Access Compliance Report Public Rights-of-Way (Curb Ramps)

Main Street: HARPER_ST Cross Street: BOLSA_AVE Location: SW

ADA ID: RPRK211004182621 Ramp Type: Type 1 - Perpendicular Diagonal Initial Pass/Fail: Fail Overall Compliance: No Severity Score: 20

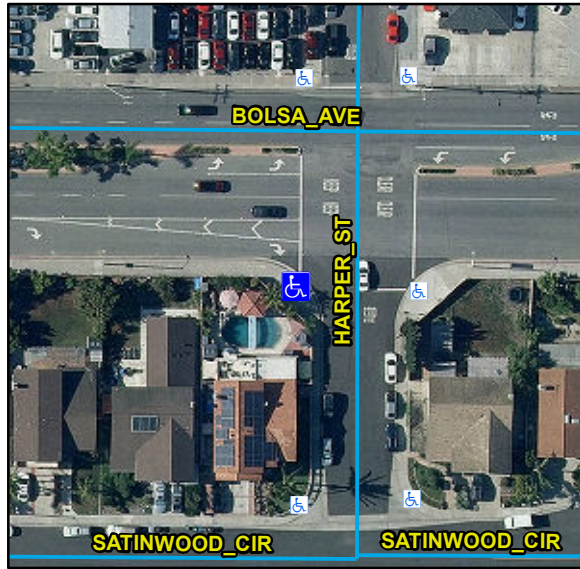
Compliance	Description	Data	Compliance	Description	Data
N/A	Ramp Length (in)	111	N/A	Flare Type LT	
No	Ramp Width (in)	36			N/A
No	Ramp Run Slope (%)	10.5	N/A	Flare Slope LT (%)	N/A
No	Ramp Cross Slope (%)	3.5	N/A	Flare Traversable LT	N/A
N/A	Landing Present	N/A	N/A	Flare Type RT	
N/A	Landing Length (in)	N/A			N/A
N/A	Landing Width (in)	N/A	N/A	Flare Slope RT (%)	N/A
N/A	Landing Run Slope (%)	N/A	N/A	Flare Traversable RT	N/A
N/A	Landing Cross Slope (%)	N/A	N/A	DWS Provided	N/A
N/A	Landing Movement Obstructed?	N/A	N/A	DWS Contrast	N/A
	Landing Movement Type	N/A	N/A	DWS Length (in)	N/A
N/A	Landing Shared	N/A	N/A	DWS Full Width	N/A
N/A	Clear Space	Yes	N/A	DWS Offset Left (in)	N/A
N/A	Clear Space To Crosswalk (in)	N/A	N/A	DWS Offset Right (in)	N/A
N/A	Marked Crosswalk 1	No	N/A	Marked Crosswalk 2	No
	Crossing 1 Direction	E		Crossing 2 Direction	N
	Marked Crosswalk 1 Width (in)	N/A		Marked Crosswalk 2 Width (in)	N/A

N/A	Ramp Inside Crosswalk 1	N/A	Yes	Ramp Inside Crosswalk 2	N/A
	Crossing 1 Slope (%)	10.7		Crossing 2 Slope (%)	1.6
	Crossing 1 Cross Slope (%)	1.1		Crossing 2 Cross Slope (%)	1.4
N/A	Gutter Ponding	N/A	No	Curb Slope	7.3
Yes	Gutter Lip Height (in)	0		Road Run Slope (%)	0.3
N/A	Gutter Run Slope (%)	N/A		Road Cross Slope (%)	8.6
N/A	Gutter Cross Slope (%)	N/A			
Yes	Overall Surface Condition: Acceptable		Yes	Perp Joint Present	Yes
	Cross Gutter Present?	No		Spandrel Present?	Yes
	Replace Cross Gutter?	N/A		Replace Spandrel?	No

Possible Solutions:

Remove & Replace Curb Ramp With Two New Directional Ramps or Equivalent.

R304.2.2, R304.5.1, R304.5.3, STD 1115
